Inter-Office Memorandum

SUBJECT: DRC Meeting Date: October 18, 2016
Final Site Plan Application
Family Dollar Store on Derbyshire Road
2016-F-FSP-0204, RSN 855756

STAFF REVIEW COMMENTS

**Meeting Date: October 12, 2016
Family Dollar Store on Derbyshire Road
2016-F-FSP-0204, RSN 855756**

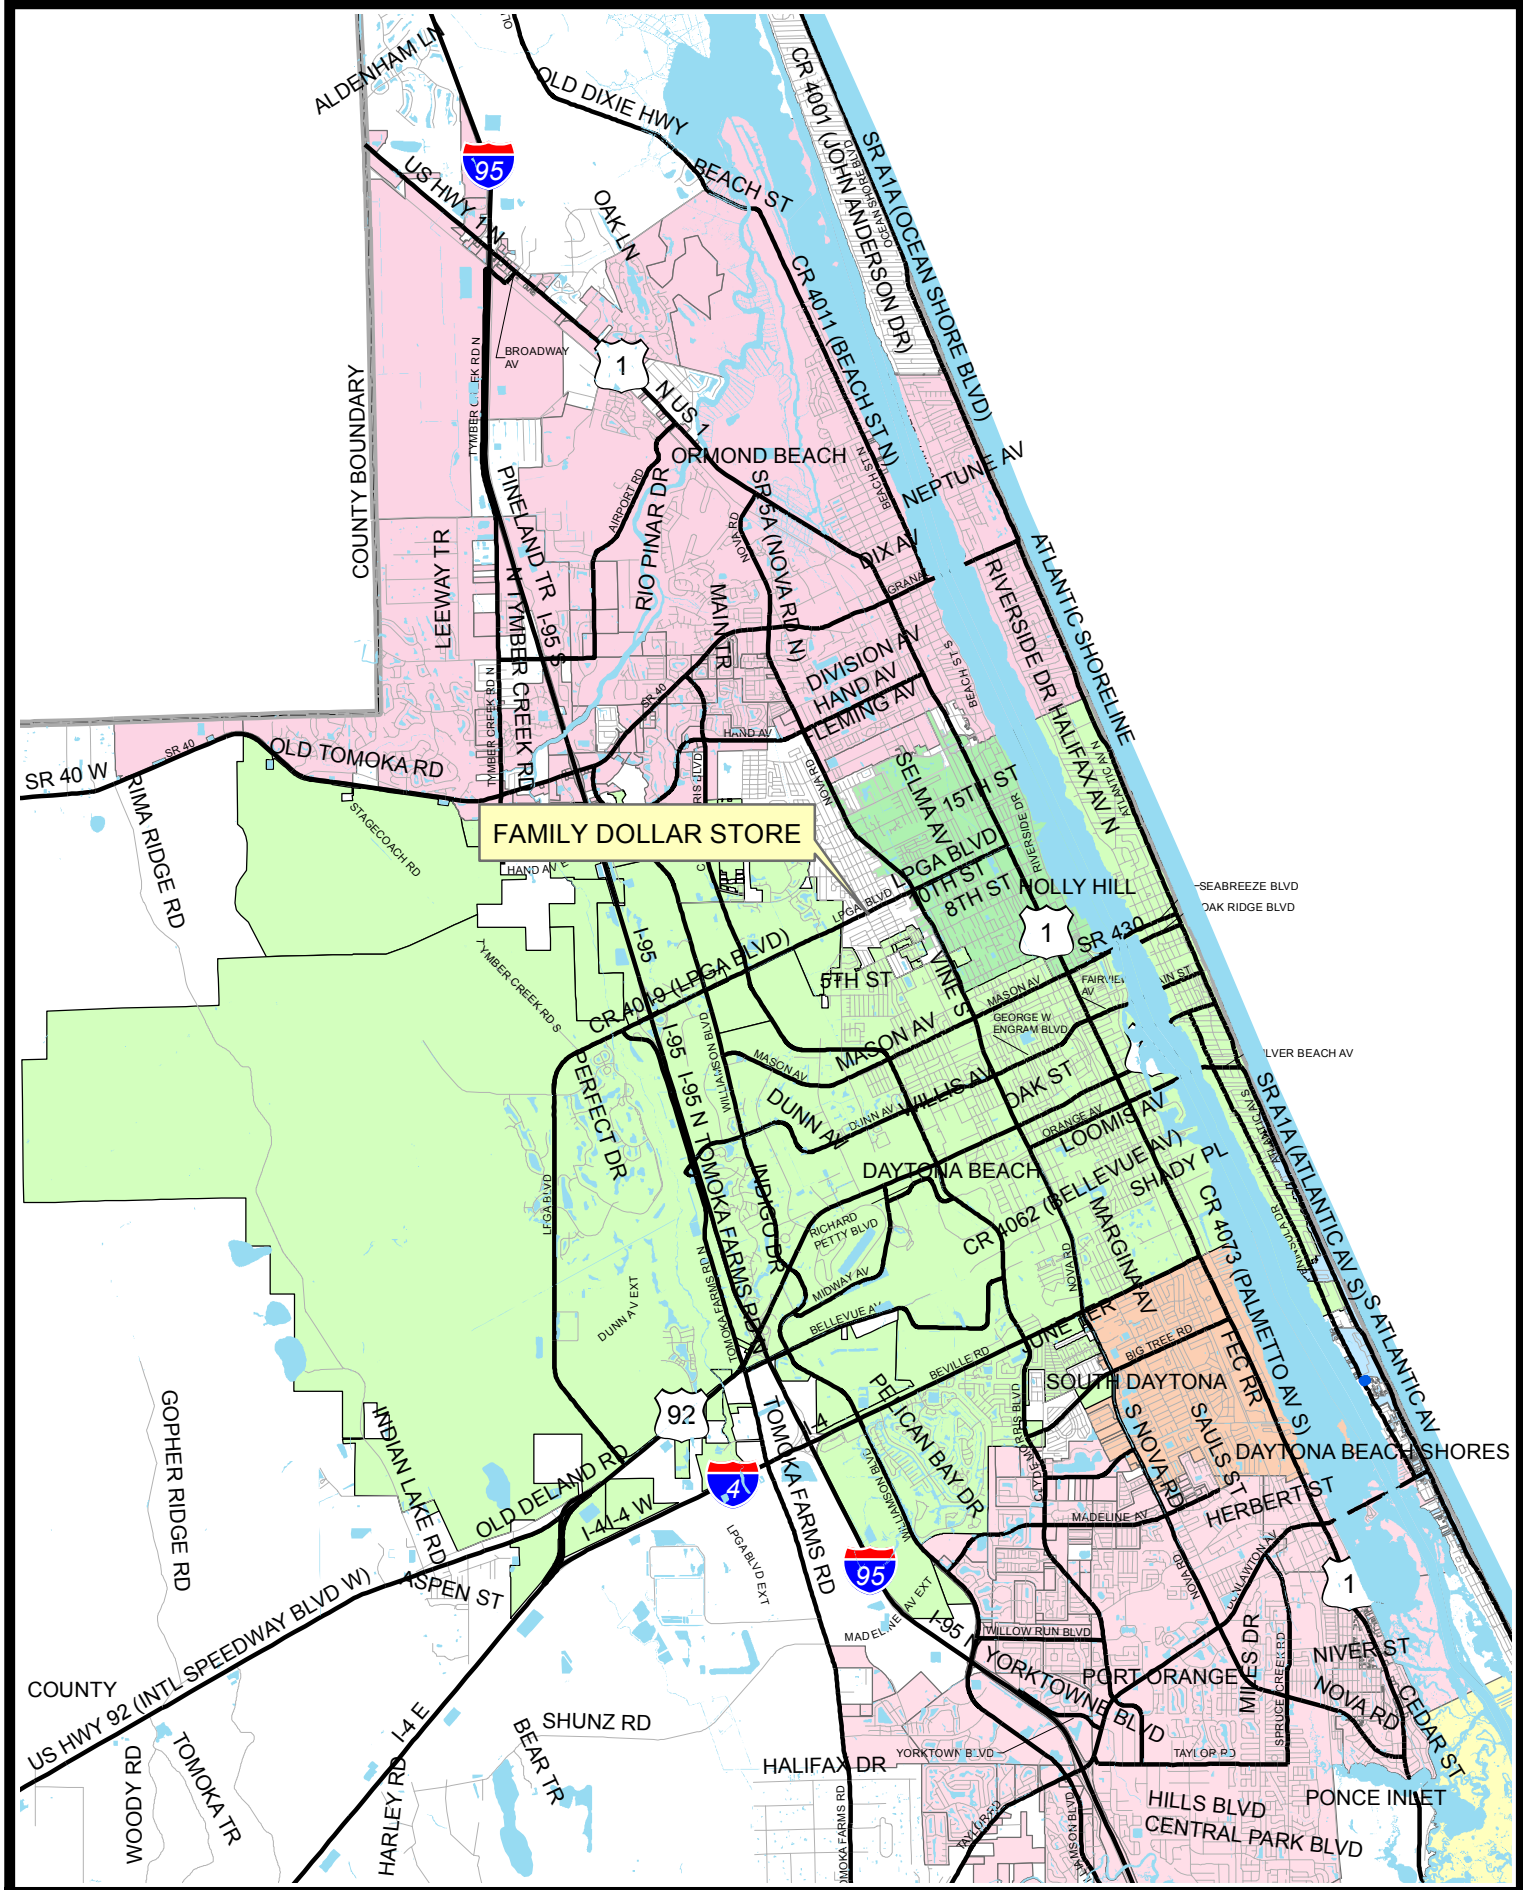
1. Grant an easement to the adjacent property on LPGA Boulevard for the future joint access connection as shown on the plans.
2. Clarify the plans to limit the depiction of the demolition of the existing driveways within LPGA Boulevard and Derbyshire Road to the Site Demolition Plan (Sheet C-4).

2. Crape myrtles must have at least one trunk with a minimum caliper of 2 inches to be used as replacement stock pursuant to Section 72-842 of the LDC. Show on the plan set that the crape myrtles being planted are standards and not multi trunk.
